Amendment 7**Date: 29.01.2020****NIT No.** RECTPCL/PIA/JKPDD/SS-03**Name of Works:** Design, Manufacturing, Supply, Erection, Testing & Commissioning of below mentioned Substations and bay on Turnkey Basis associated with Strengthening of Transmission System of JKPDD under PMDP Scheme-15:-

- i) 220/33 kV GIS Substation at Diskit (Nubra)
- ii) 220/33 kV GIS Substation at Padum (Zanskar)
- iii) 220kV Line Bay at PGCIL's existing GIS Substation at Phyang
- iv) 220kV Line Bay at PGCIL's existing GIS Substation at Drass

Amendment 7 Dated 29.01.2020 for RECTPCL NIT No. RECTPCL/PIA/JKPDD/SS-03

REC TRANSMISSION PROJECTS COMPANY LIMITED
PROJECT	OGA OF 220/33kV DISKIT SUBSTATION
SUBSTATION	220/33kV GIS DISKIT SUBSTATION
DRG. TITLE	TYPICAL LAYOUT PLAN 220/33kV DISKIT S/S
DRG. NO.:	
SCALE:

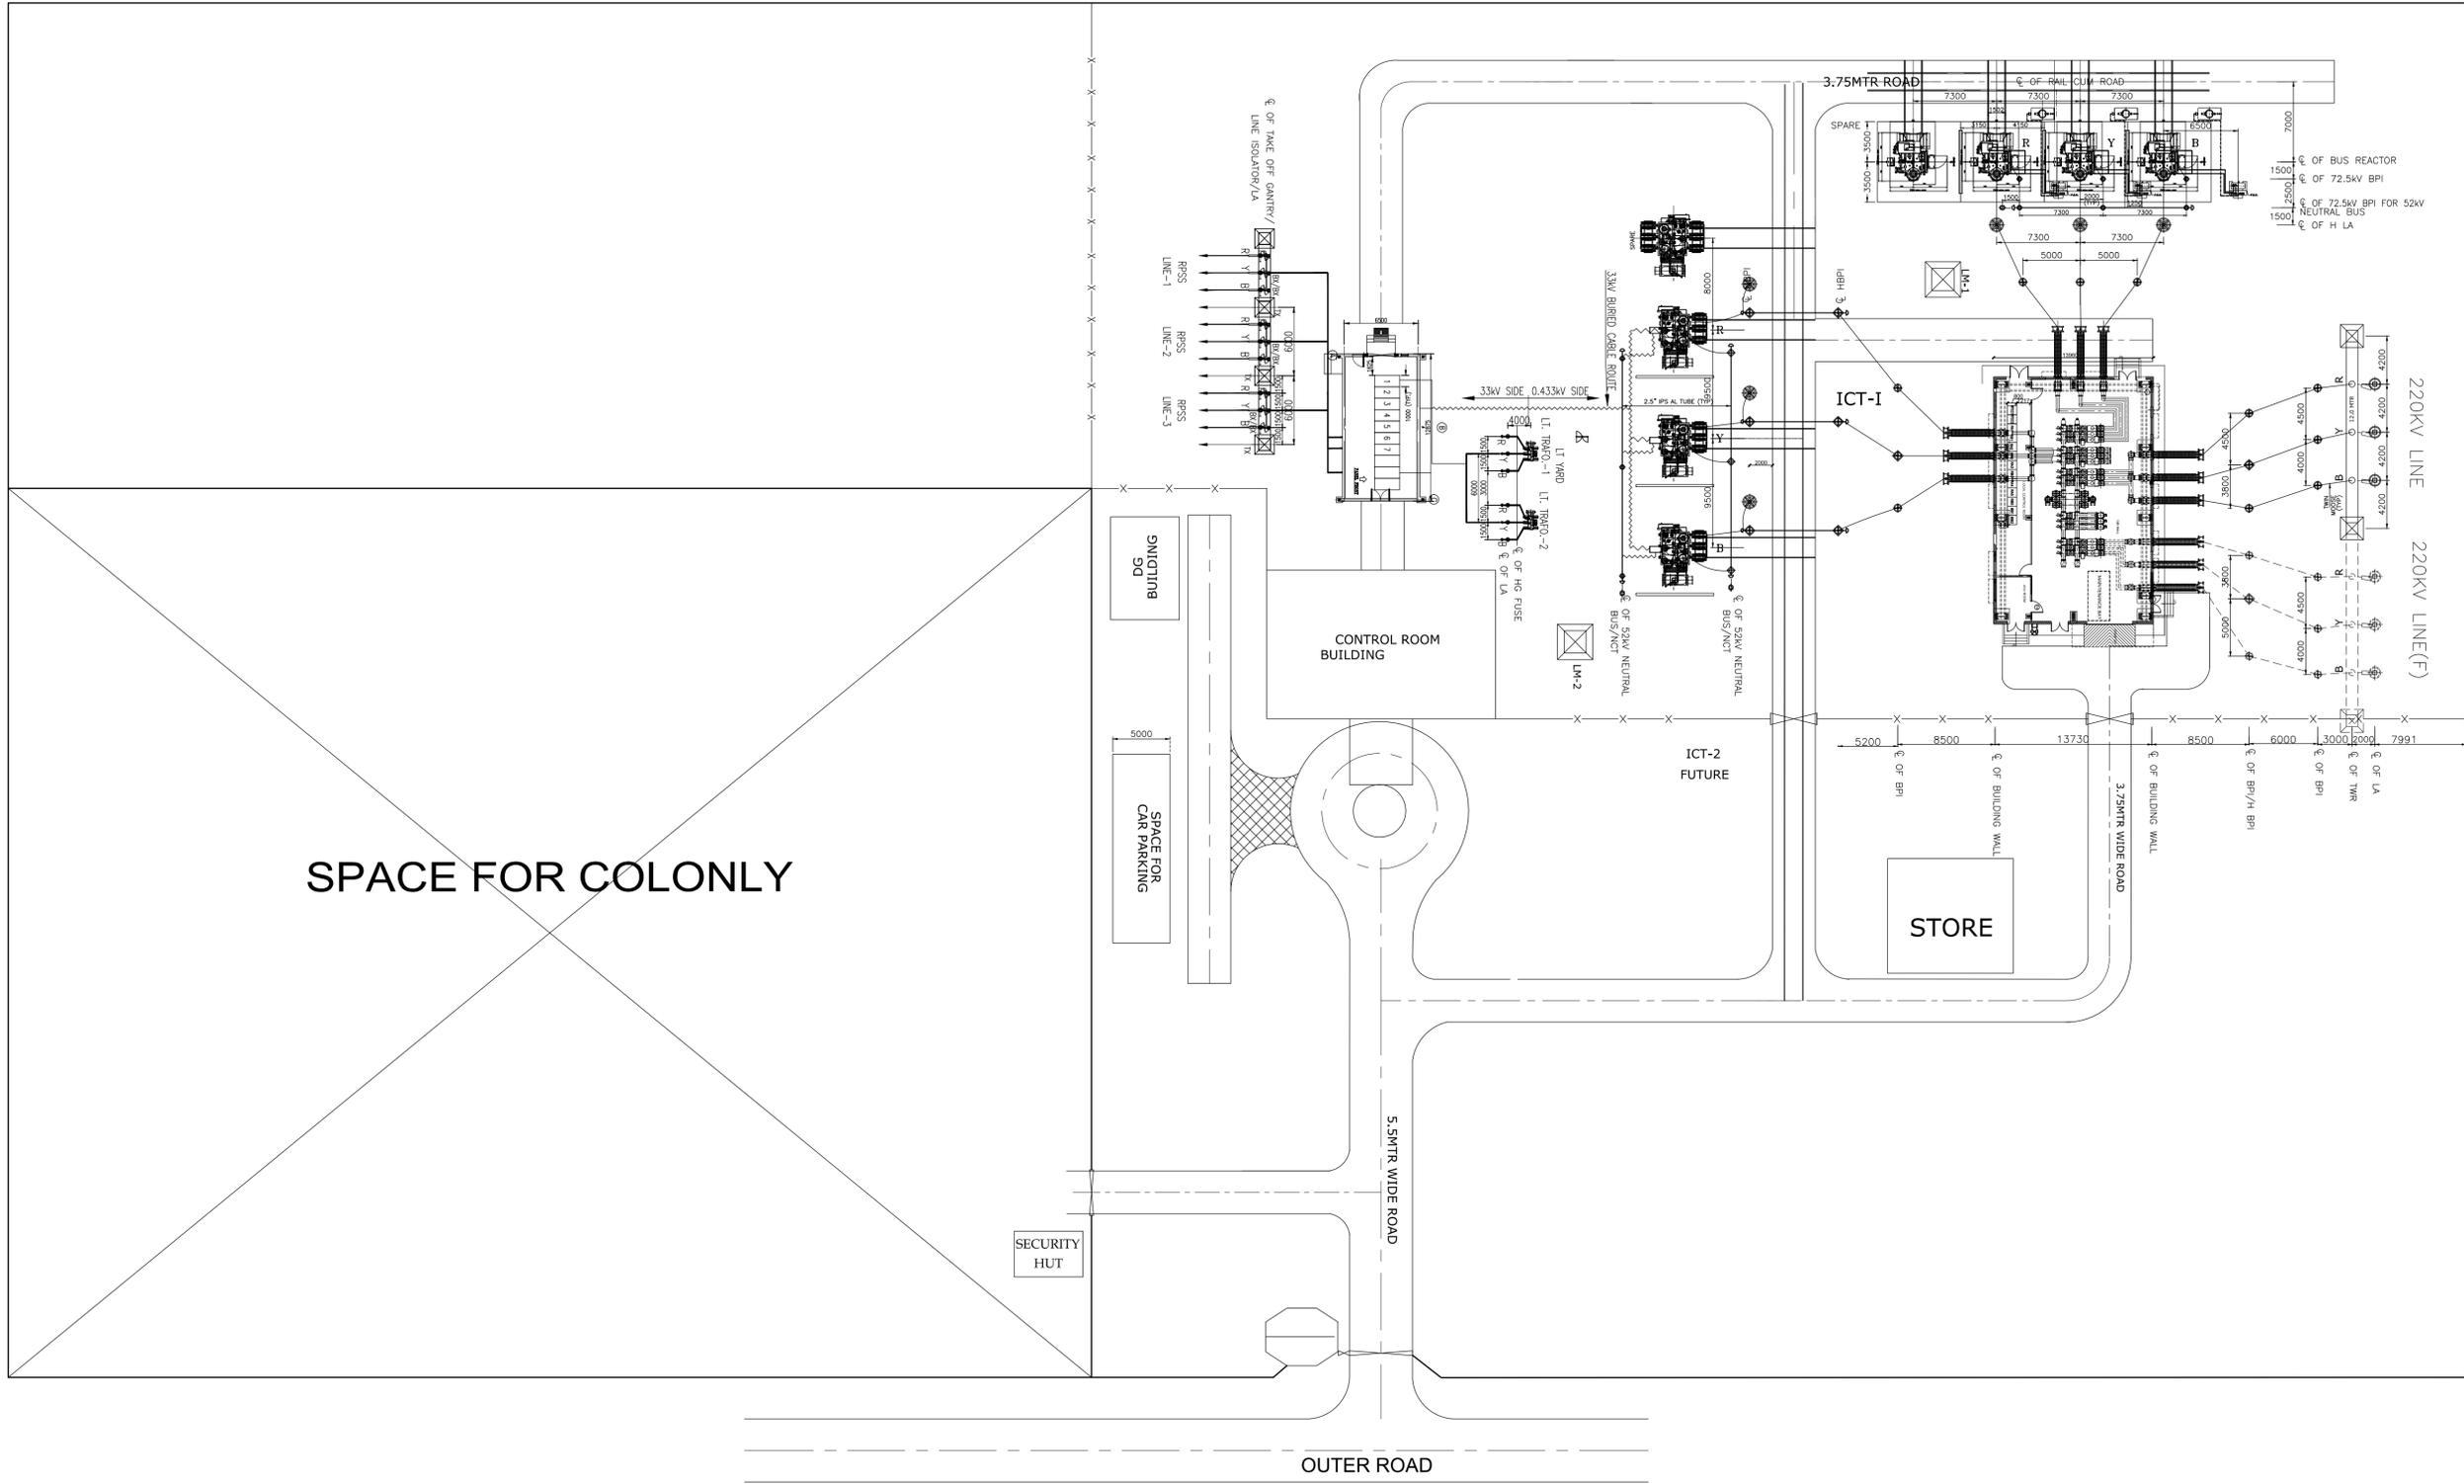
4.1.1.1 (Clause No. vi)	A tentative layout / GA drawing no. (RECTPCL/LADAKH / DIS / GA / 04) of the switchyard is enclosed with this specification for 220/33kV Diskit (GIS) Substation.		Tentative Layout/GA for proposed Diskit GIS is attached at Annexure A of this Amendment.

Sr. No.	Annexure Ref. No.	Tender Clause No.	Description
1.	Annexure A	Technical Specification (Vol II) Section – 1 Project : Clause No. 4.1.1.1 (vi)	Revised Tentative Layout/GA for proposed Diskit GIS

TYPICAL LAYOUT FOR DOUBLE BUS
BAR SYSTEM
DRG NO. RECTPCL/LADAKH/GSLD/13

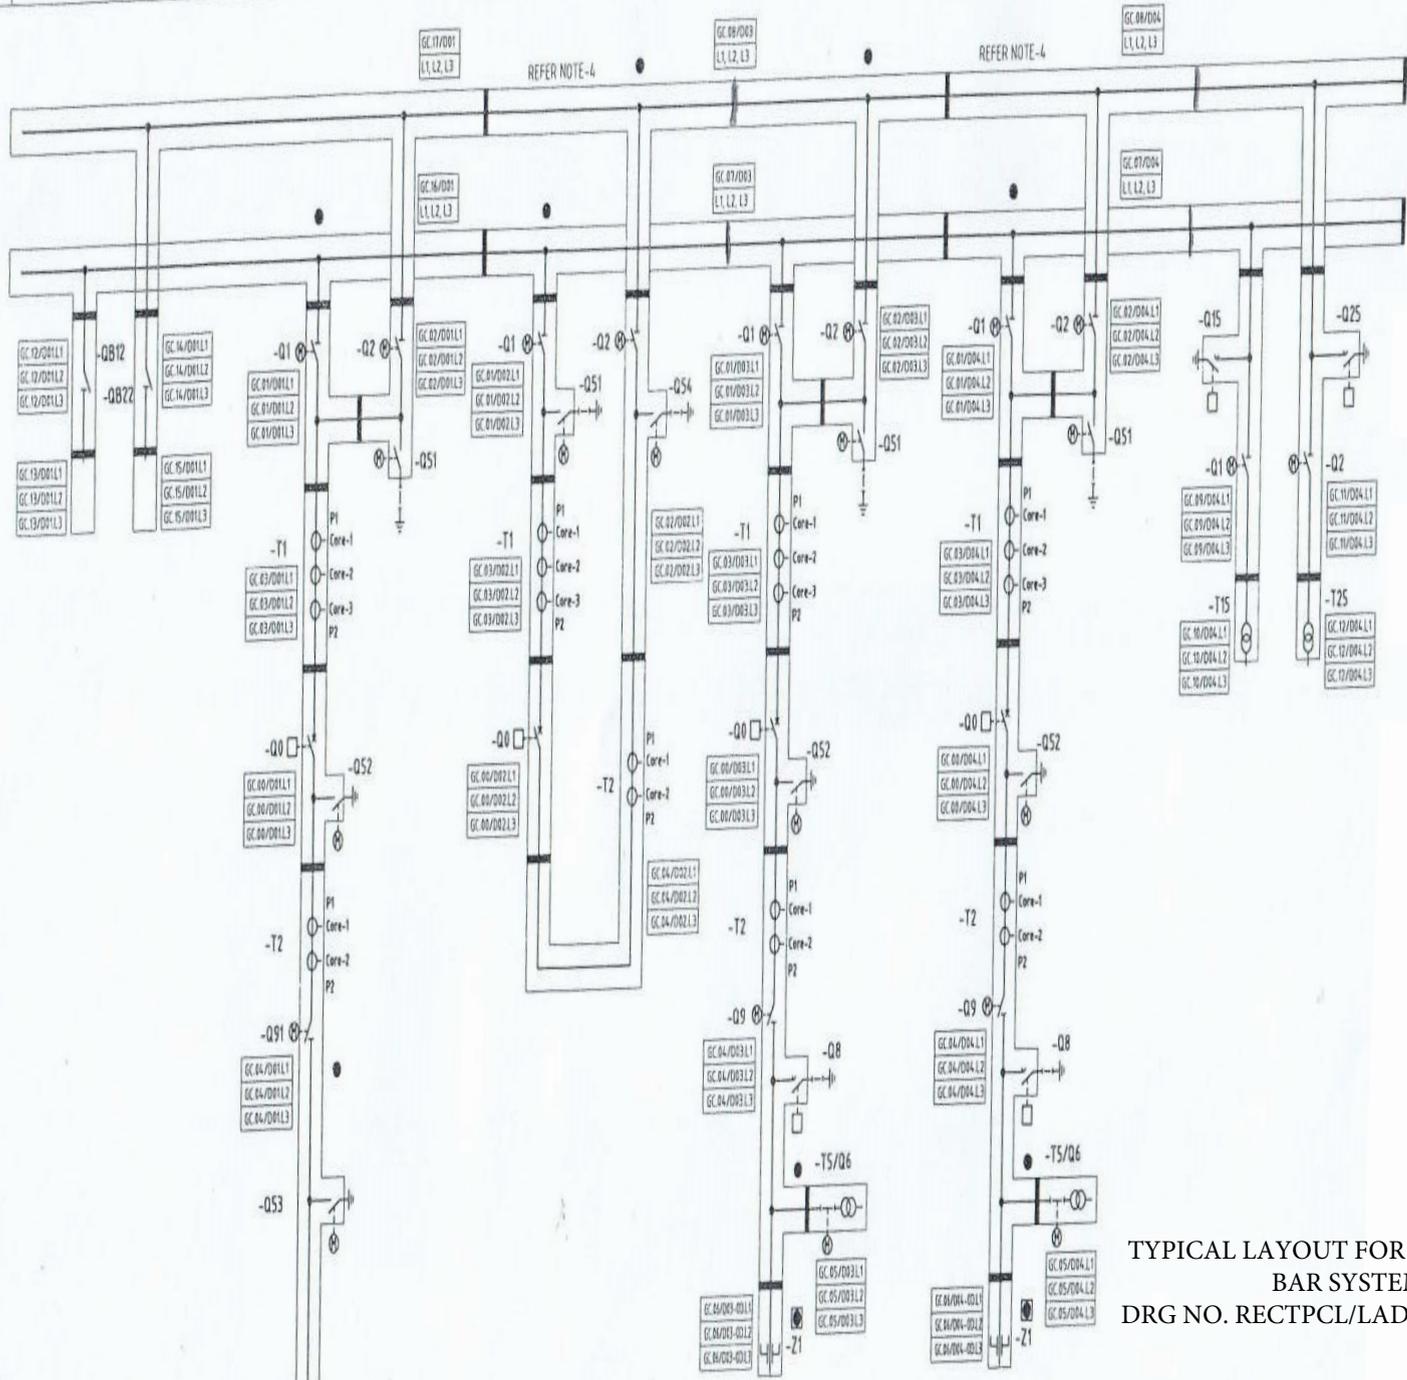
7.	Annexure G	Technical Specification (Vol II) Section – 1 Project : Annexure II	RECTPCL/LADAKH/GSLD/13 (Revised GAS SLD)
8.	Annexure H	Volume III : Price Schedule	Revised Price Schedule
